From: Cai, Cai (Shanghai) [Cai.Cai@sgs.com]
Sent: Monday, December 08, 2008 6:13 PM
To: Jennifer Sanchez; Jenn Warnell
Subject: FW: Responds Q78-ZTEMF626
Importance: High

Re: FCC ID: Q78-ZTEMF626

Applicant: ZTE Corporation

Is your device HSPA equipment. If yes what release. Where is your MPR table? Please provide detail operational description test set up of EUT

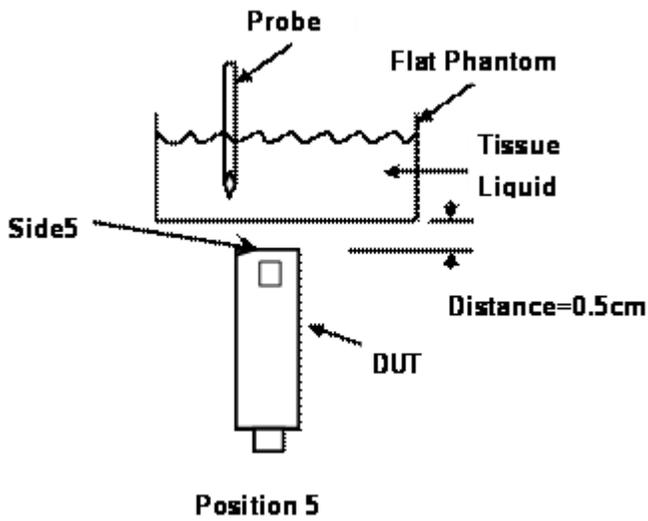
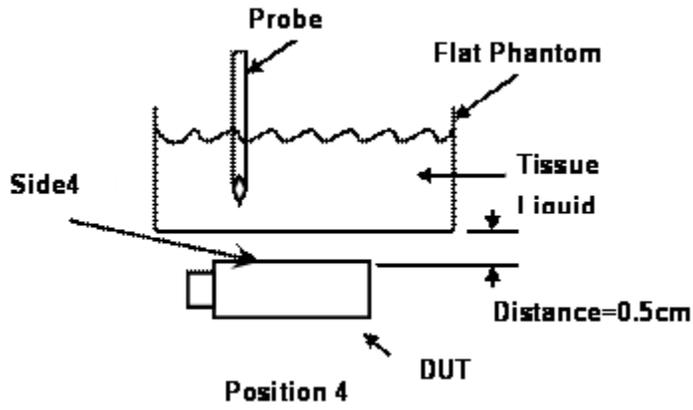
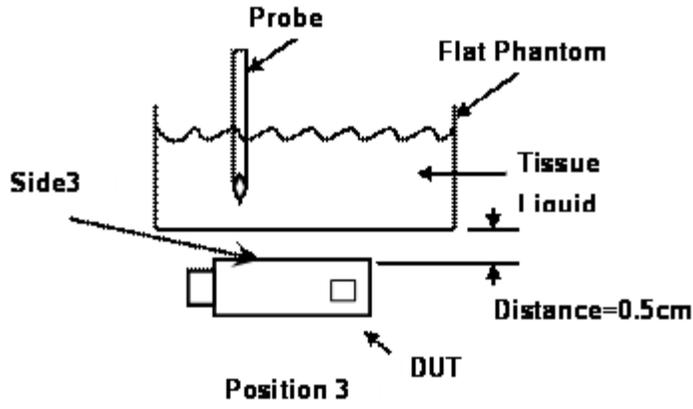
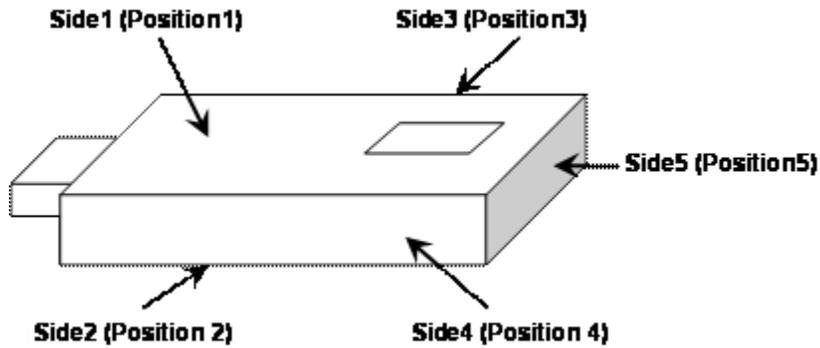
1) This is a category 8 HSDPA data device operating under 3GPP Release5; only WCDMA and HSDPA (H-set 1 sub-test 1, MPR=0, which is the worst case) are addressed in maximum output power table. MPR is special considered for HSUPA device.

We are revised the maximum output power table according to KDB 941225, in which such as UE category, sub-test1-4, etc will be clearly identified.
